PLANNING & ZONING COMMISSION MEETING

HALE TRAILER SITE PLAN HUXLEY, IOWA

RE: Hale Trailer Site Plan

RE: HUXLEY COMMUNICATIONS SITE PLAN (1955 SE OAK DR.)
SITE PLAN SUBMITTAL COMMENT RESPONSE LETTER
S&A PROJECT NO. 121.0686.01

PAVEMENT CROSS SECTIONS

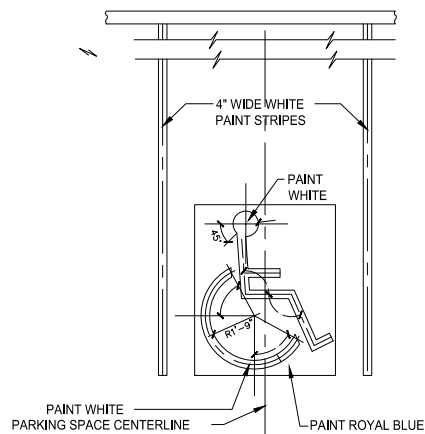
NOTE: GRAVEL PAVMENT CROSS SECTION PROVIDED BY OWNER AND DO NOT CONFORM TO ENGINEERING RECOMMENDATION

TYPICAL LIGHTING POLE FOUNDATION

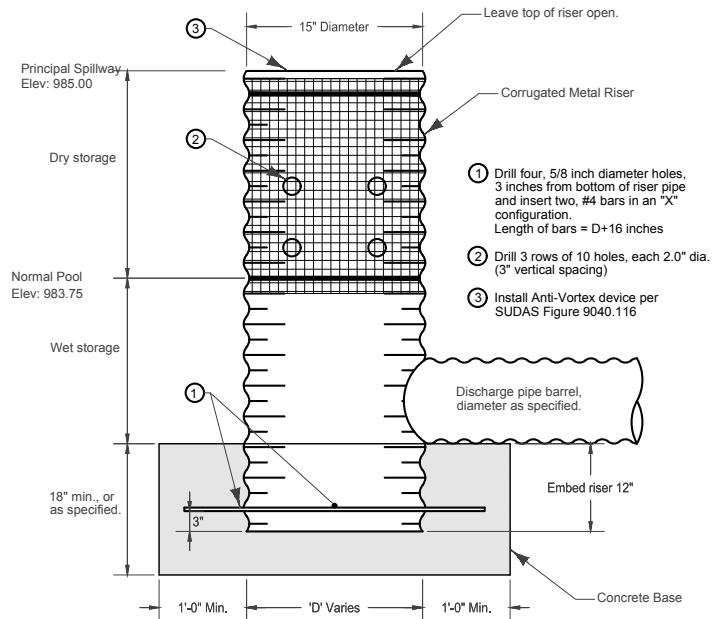
6. Provide a photo metric lighting plan.

Photometric lighting plan has been added to the submittal package as requested.

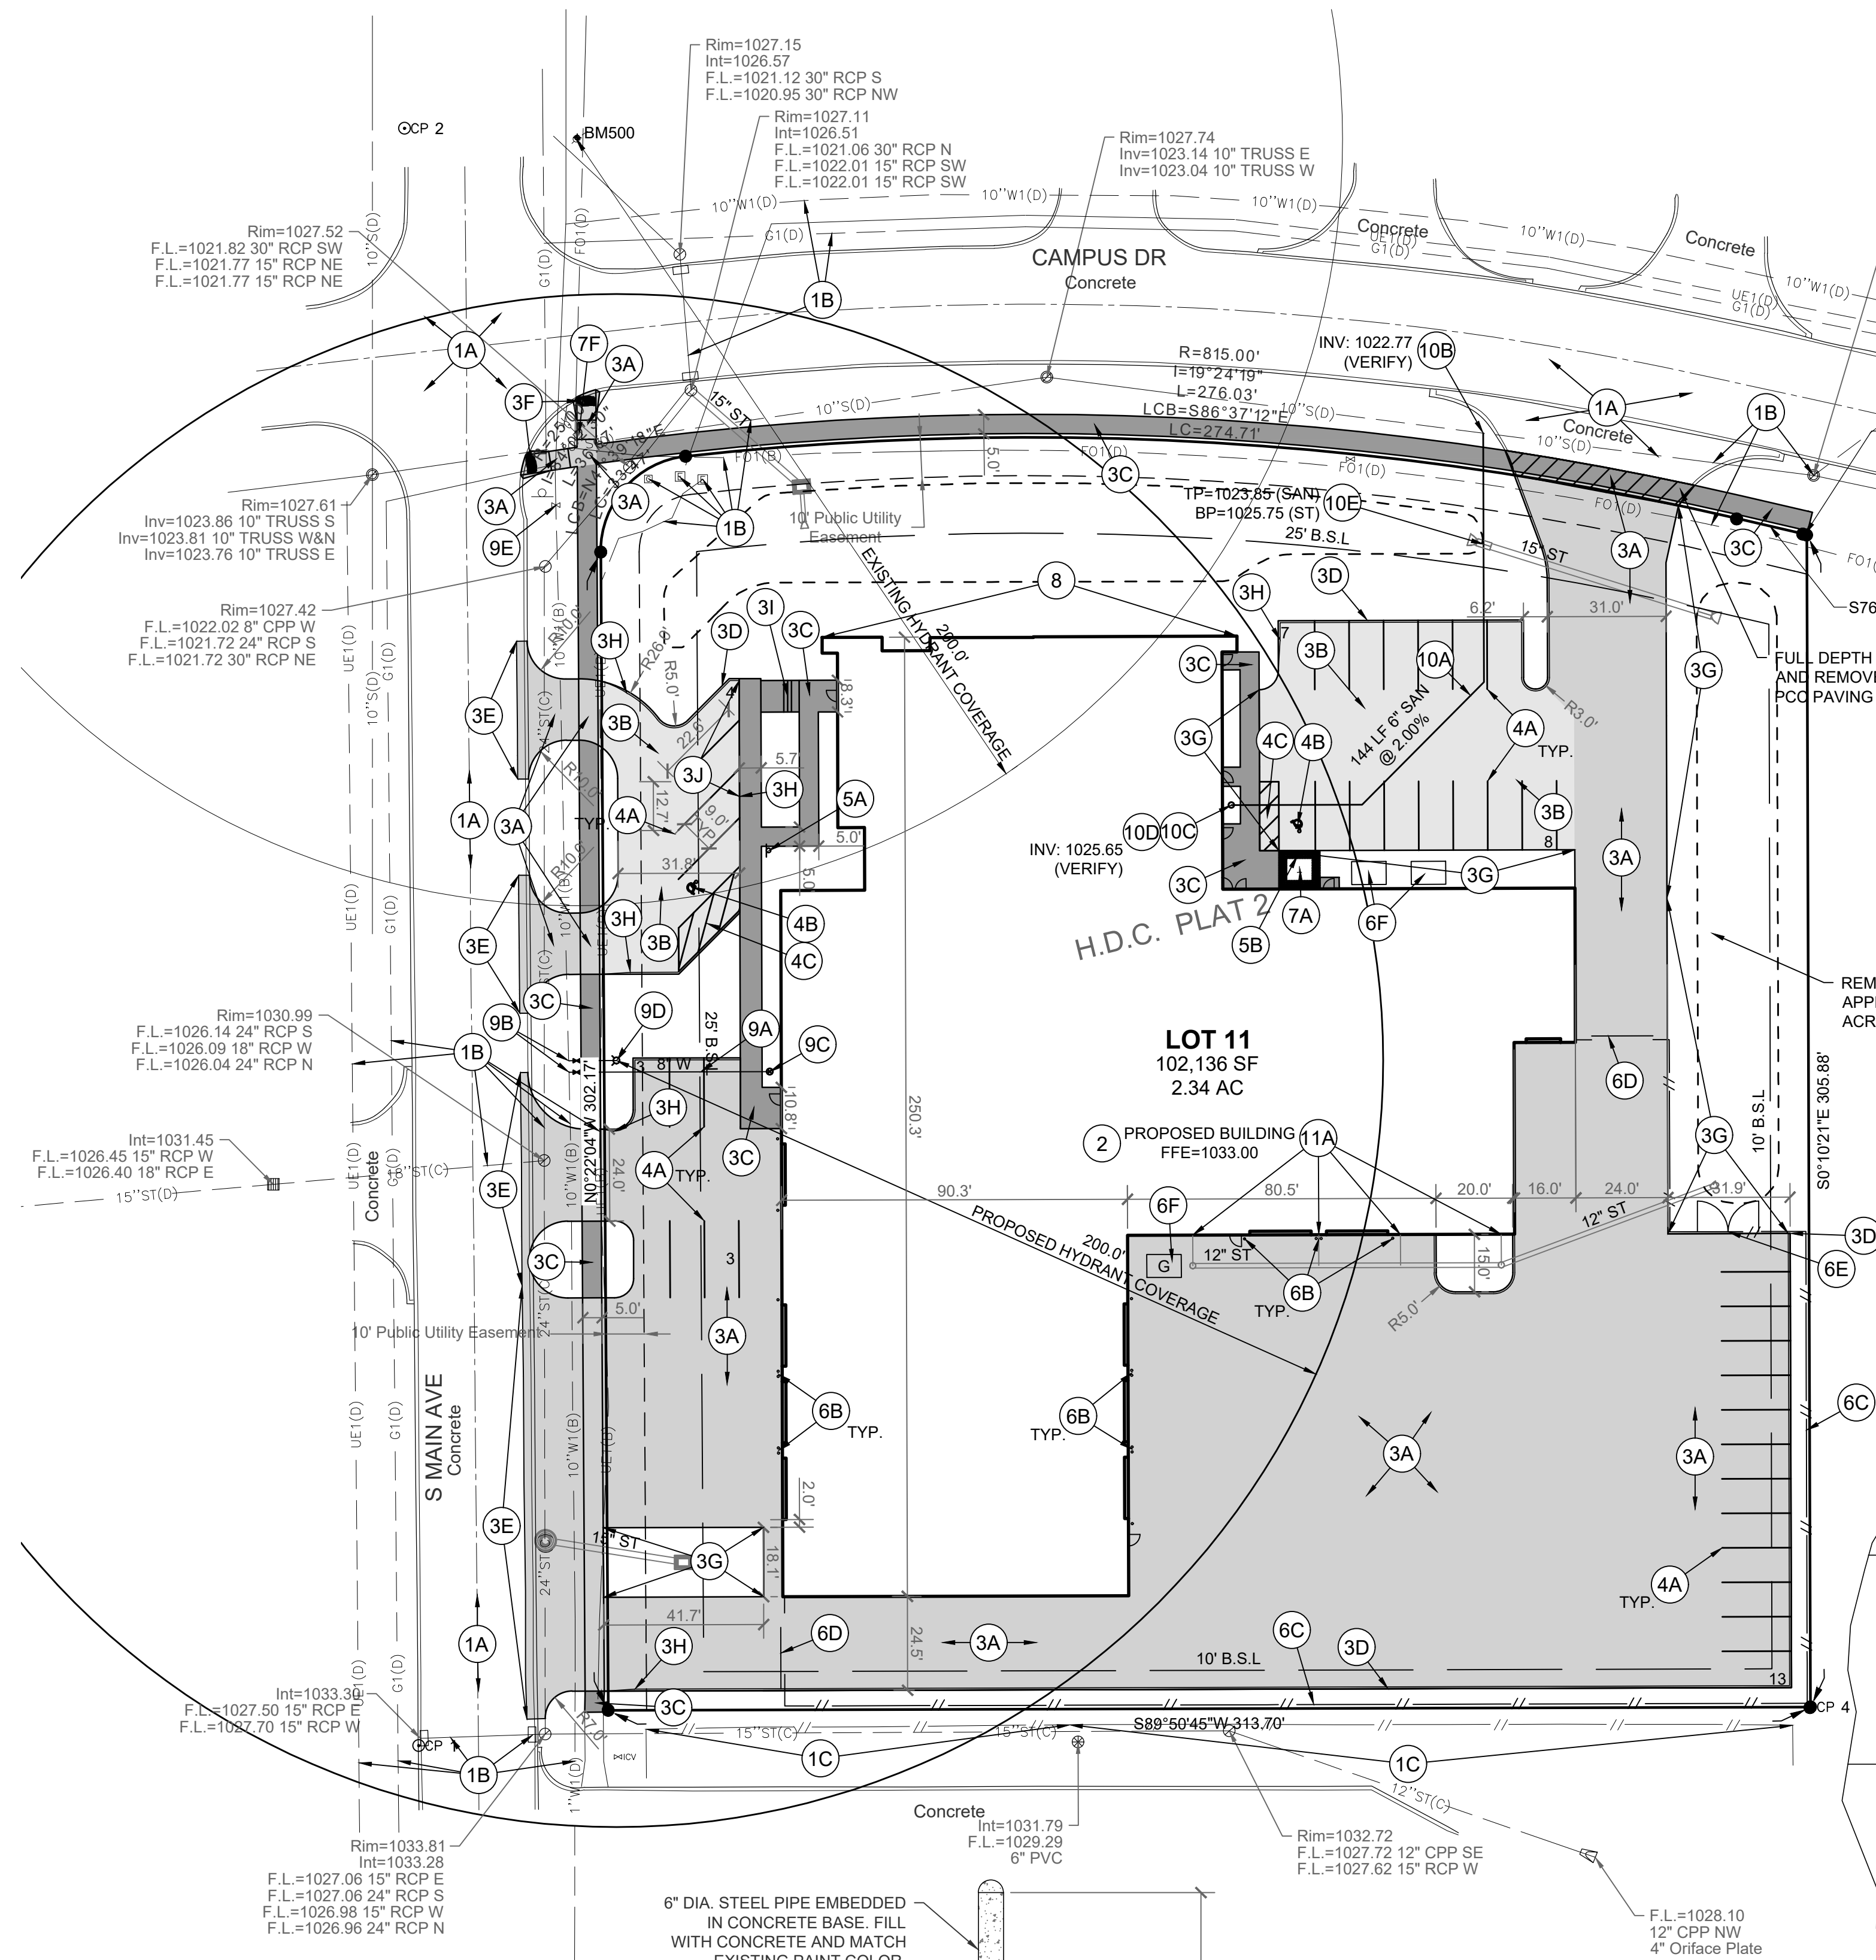
1. The water main is to be PVC C900 DR18. **Note 9.A on Sheet C1.0 updated.**
2. The fire hydrant is to have a "Storz" nozzle. **Note 9.D on Sheet C1.0 updated**

4. Terminate the tracer wire on the water service in a flush mounted tracer wire box, Drainage & Water Solutions Figure No. TWAB. Use 3M Scotchplast Splice Encapsulation Kit 3832 for all tracer wire connections. **Note 9.A. on Sheet C1.0 updated.**

11. Pipe material for the sanitary sewer service is to be PVC SDR 23.5. **Note 10.B on Sheet C1.0 updated.**
12. Insert-a-Tees are not allowed for the sanitary sewer service connections. Use connections as allowed in the Huxley Supplemental Specifications. **Note 10.A on Sheet C1.0 updated.**

23. Label all sidewalks to be 5-feet wide both on the plans and in the notes. **Note 3C on Sheet C1.0 updated. All sidewalks drawn at a minimum width of 5'.**

25. A streetlight pole and utility handhold box may need to be relocated at the intersection of Main and Campus to accommodate the pedestrian ramps. Please verify. **Note 7.F. on Sheet C1.0 added to address relocating the streetlight outside of the sidewalk.**

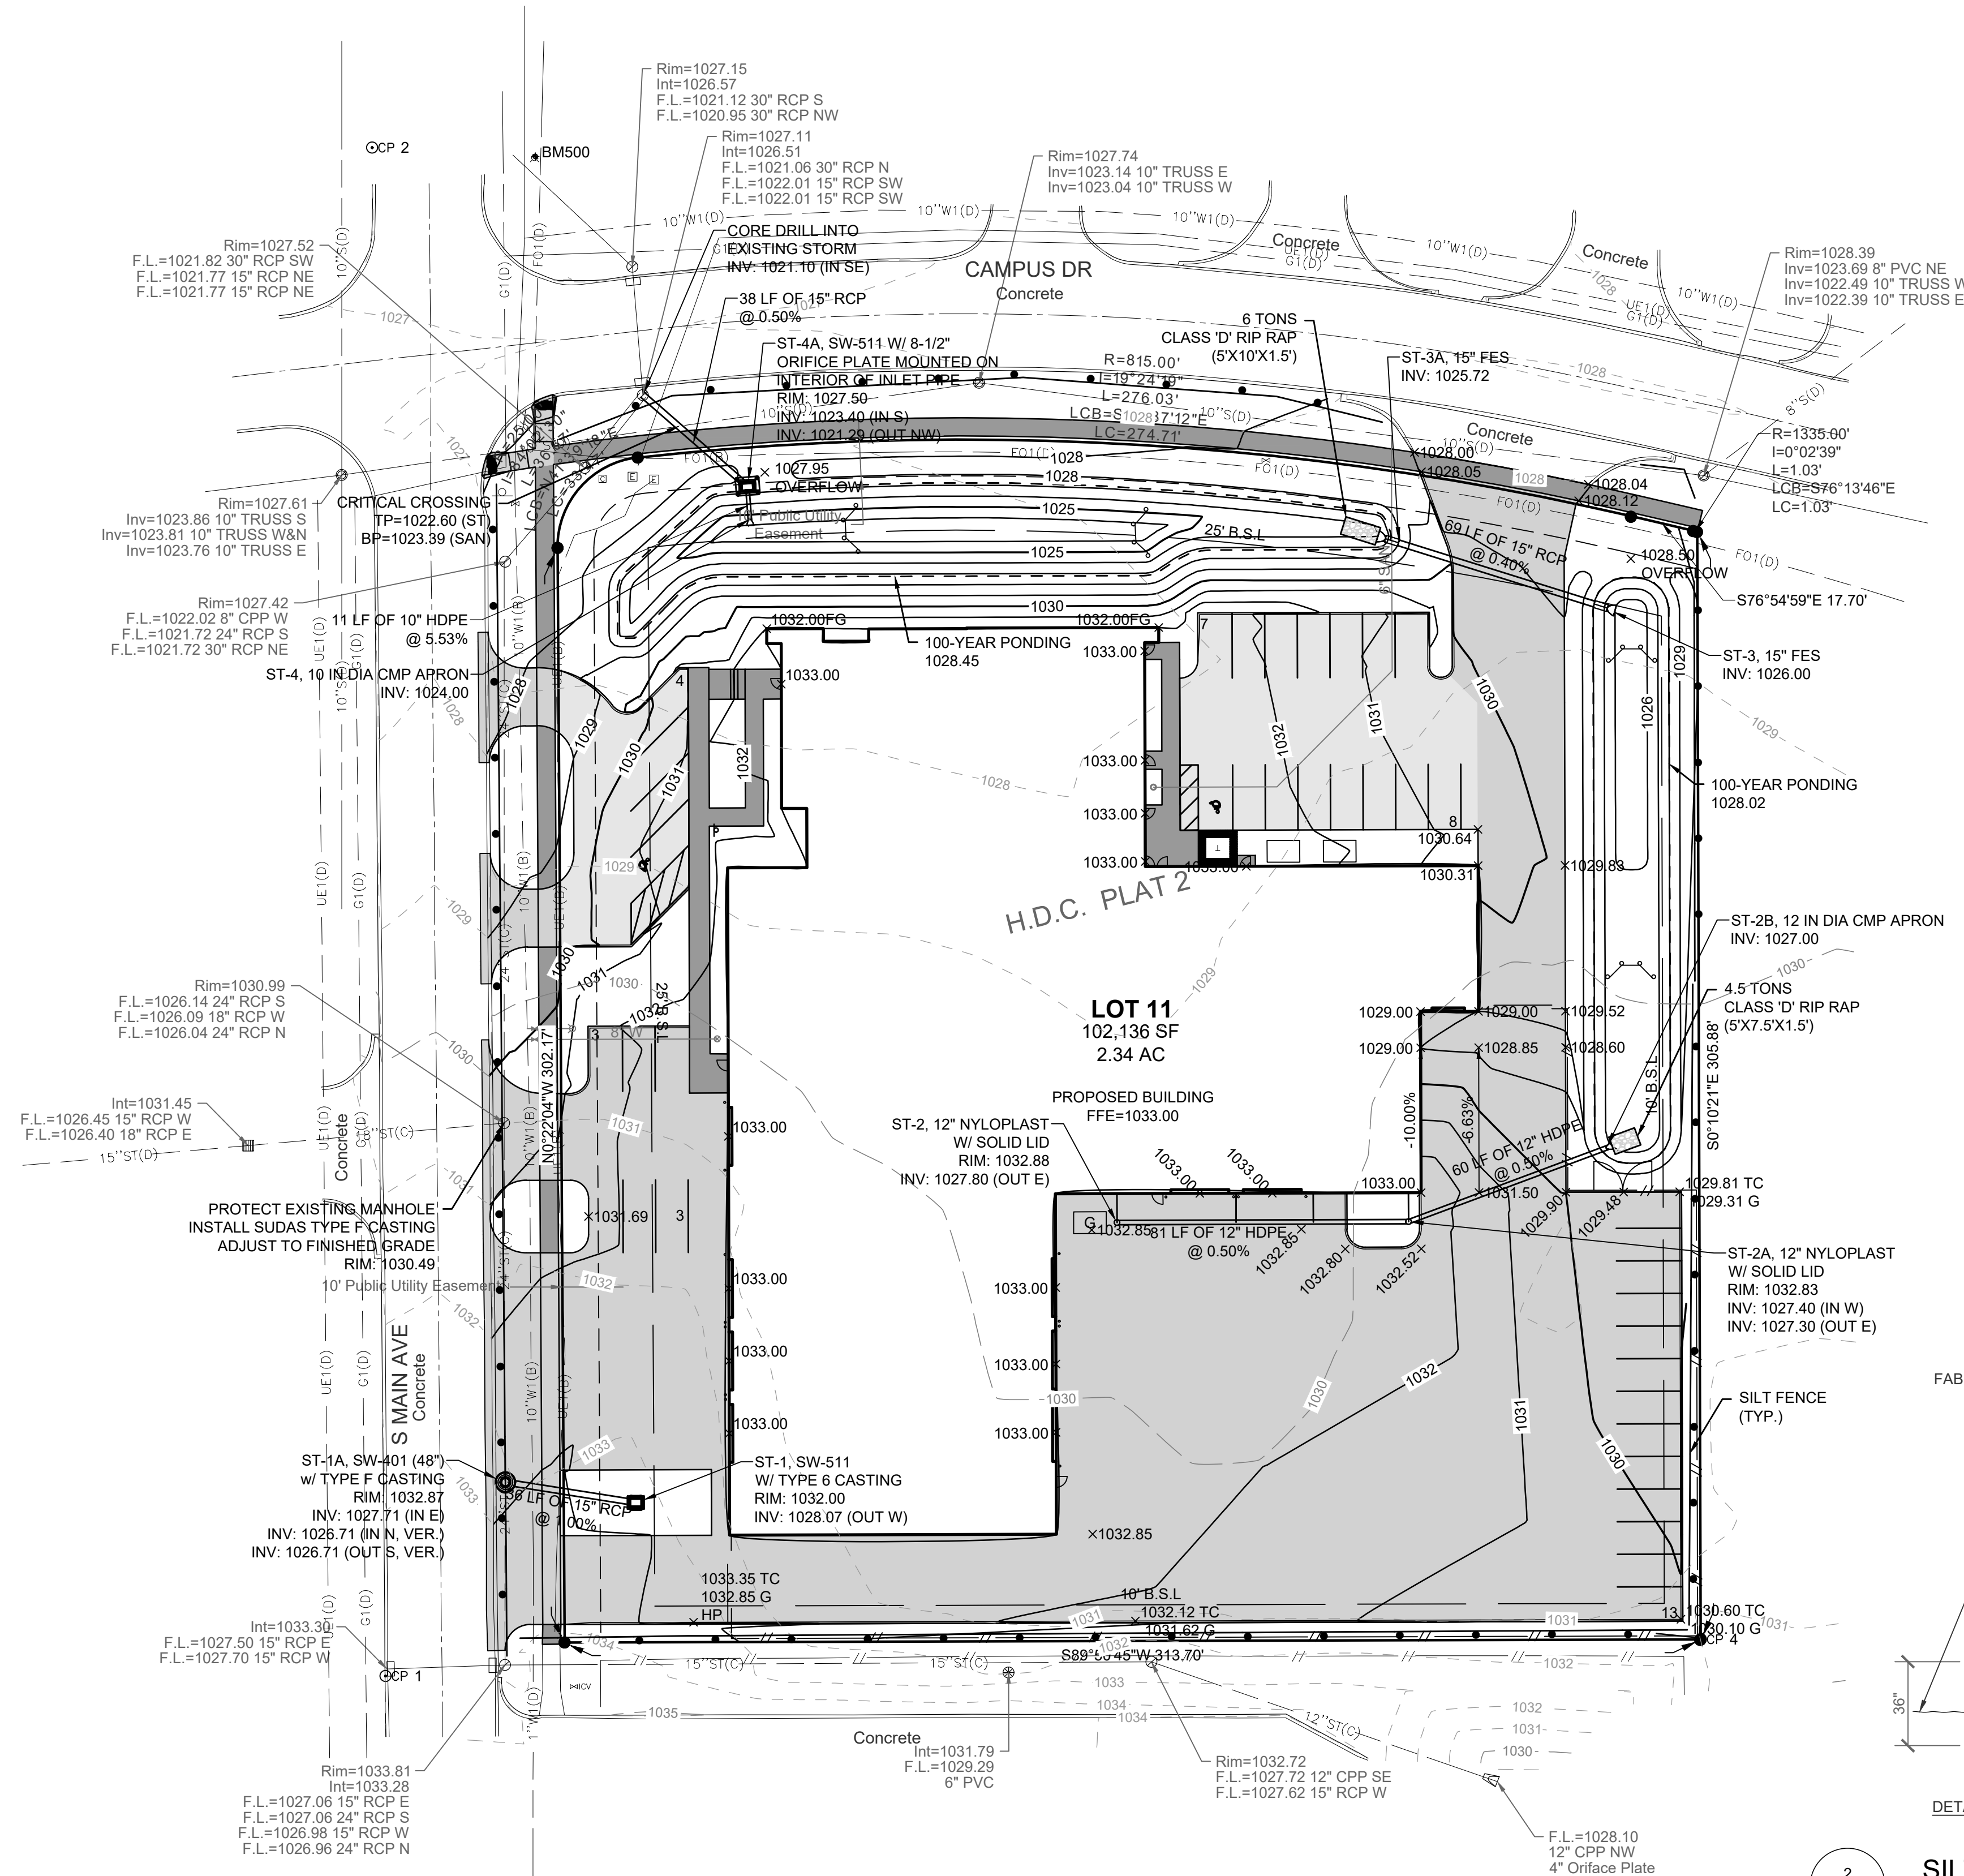
27. The existing storm sewer manhole casting in the west driveway will need to be replaced with a floating 3-piece casting. **Call out note added on Sheet C2.0 to replace this casting with Type F casting.**
